IFB: Exterior Wall Framing Repairs for Commons Dorm Apartments K4-2, K4-5

Project SU-060821

Addendum #1 \* August 19, 2021

Re: Addendum #1 – Additional Information & Clarifications

2 SECTION FOR NEW EXTERIOR WALL  
S-4

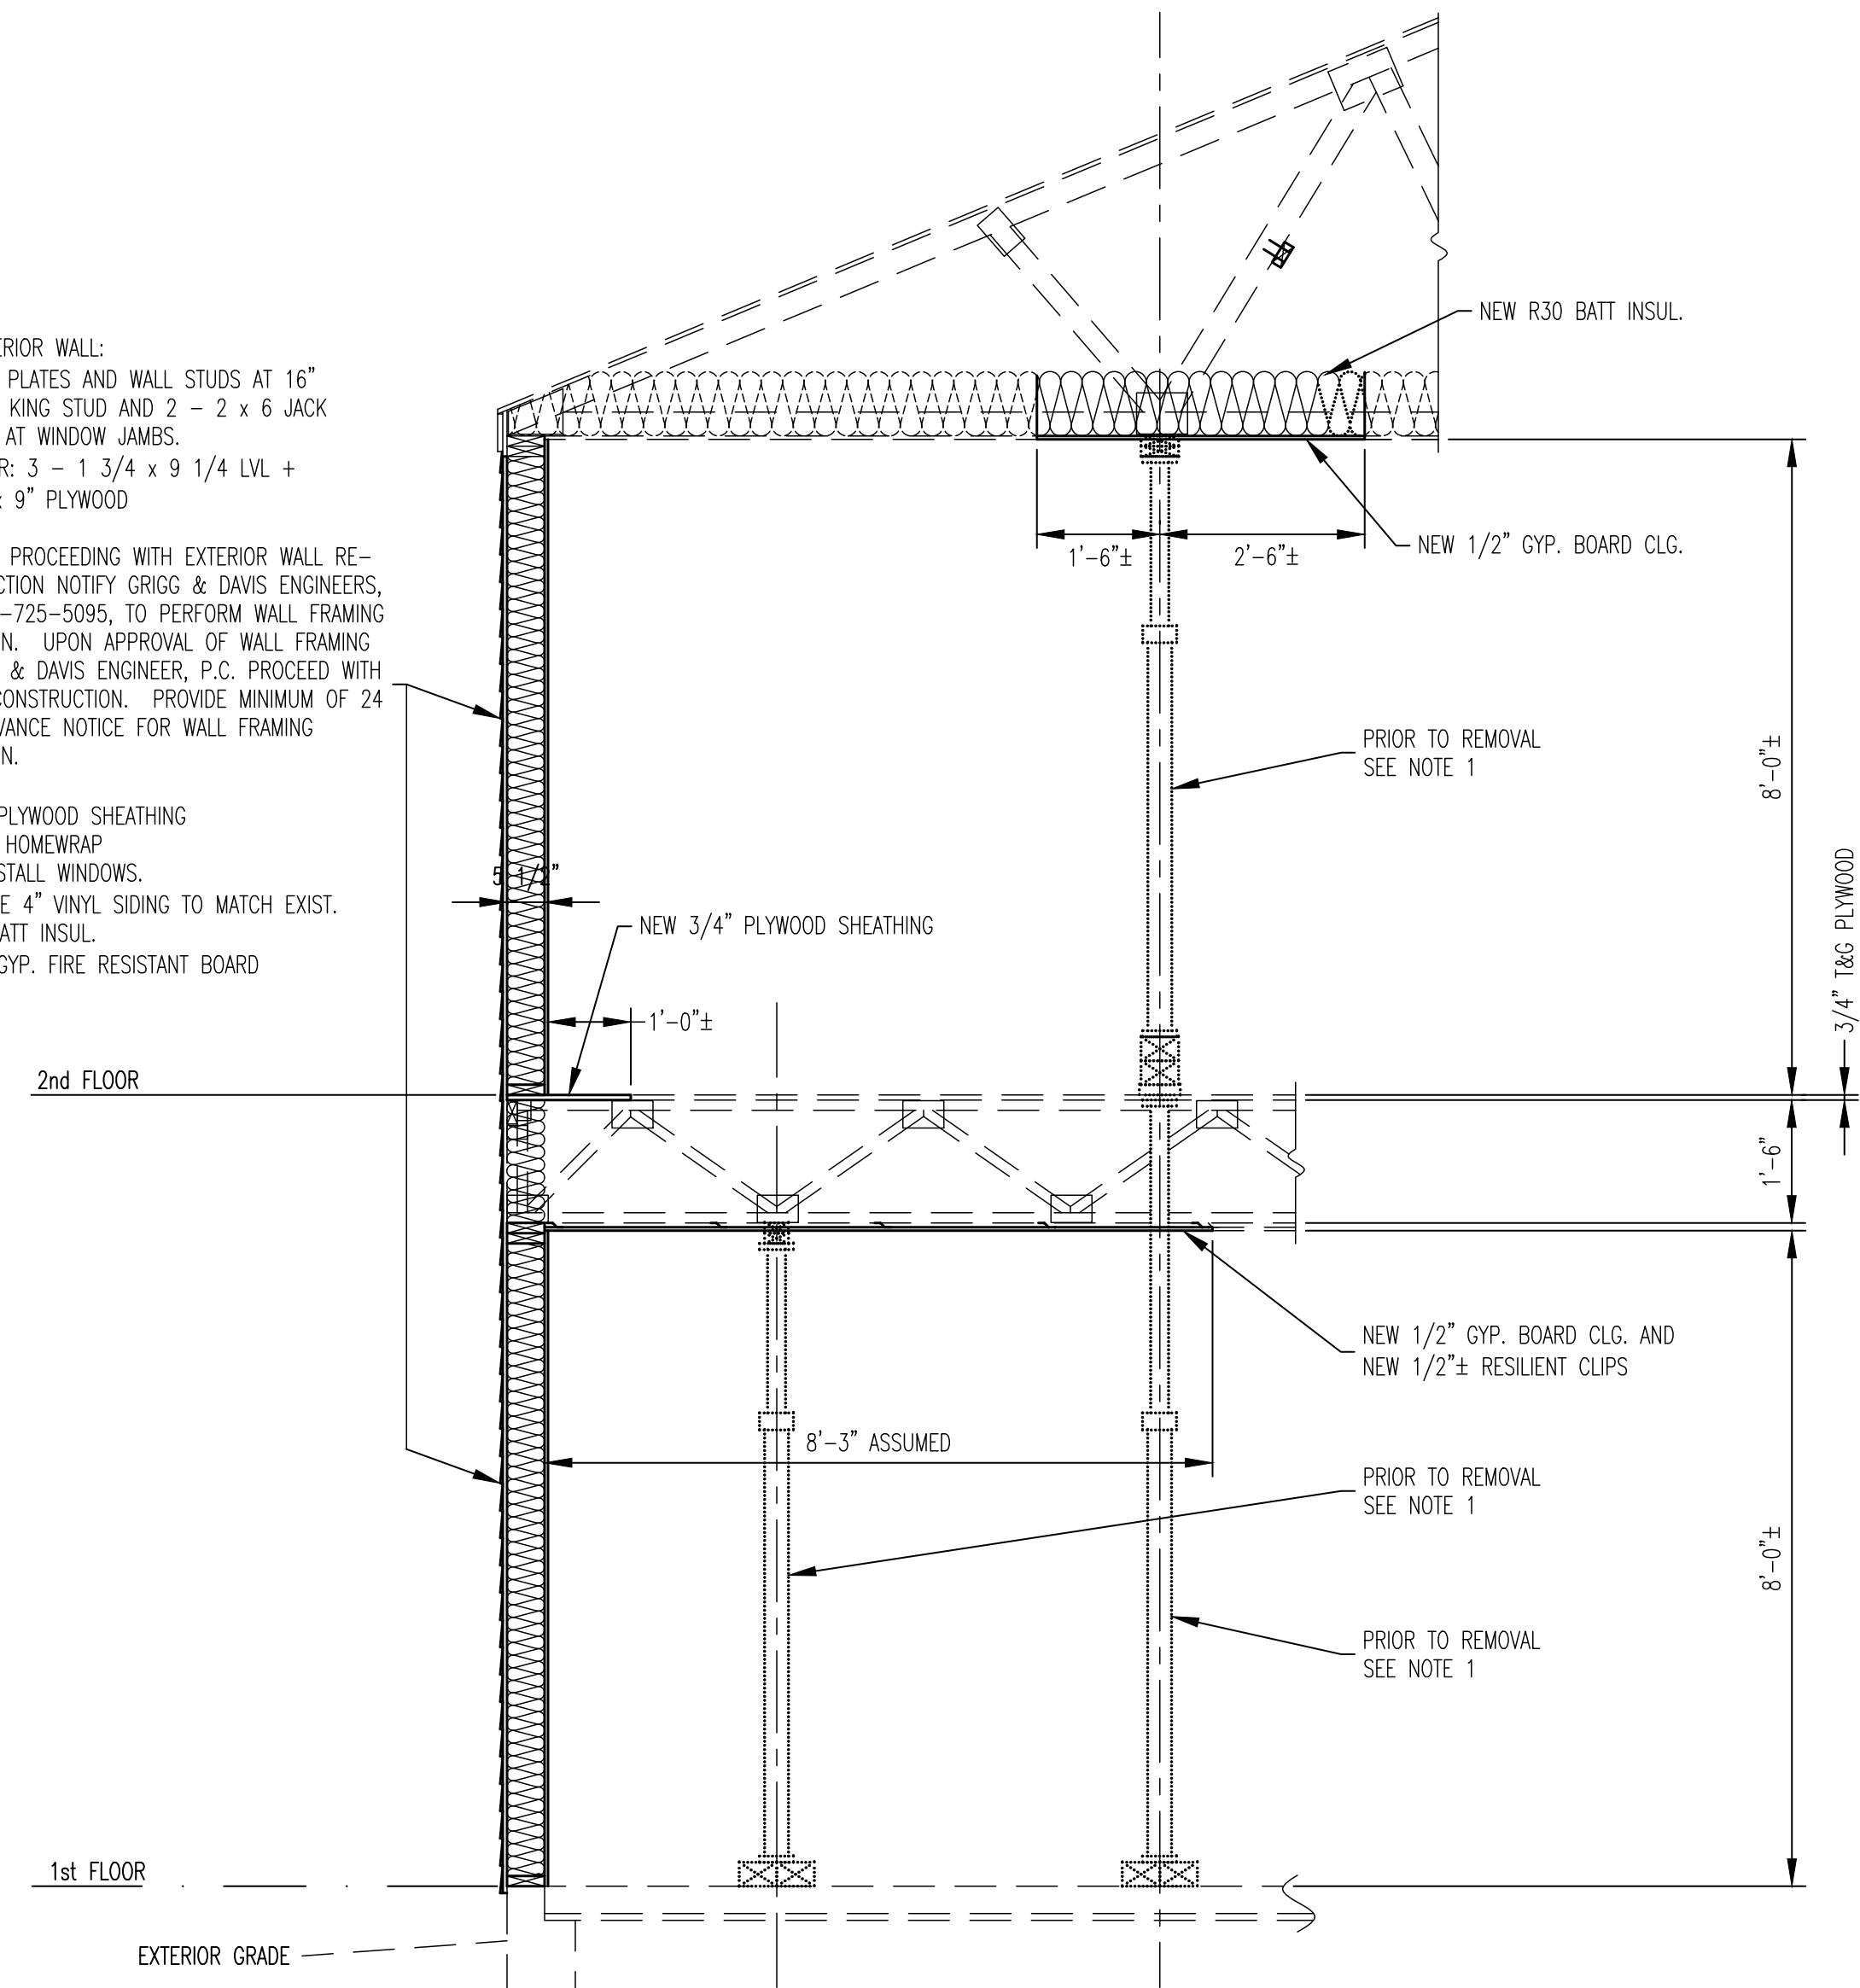
14. **Question:** Specification section 06160 – Sheathing gives a specification for pressure treated plywood were called out and fire treated plywood where called out. The drawings only call for CDX Plywood without reference to fire or pressure treated plywood. Does the ply have to be fire rated, pressure treated, or neither?

15. **Question:** Drawings call for half inch fire rated sheetrock, is it type X or type C

**Answer:** Follow the specified work shown in the contract drawings, which do not indicate using pressure treated plywood, and/or fire treated plywood.

**Answer:** Either are acceptable.
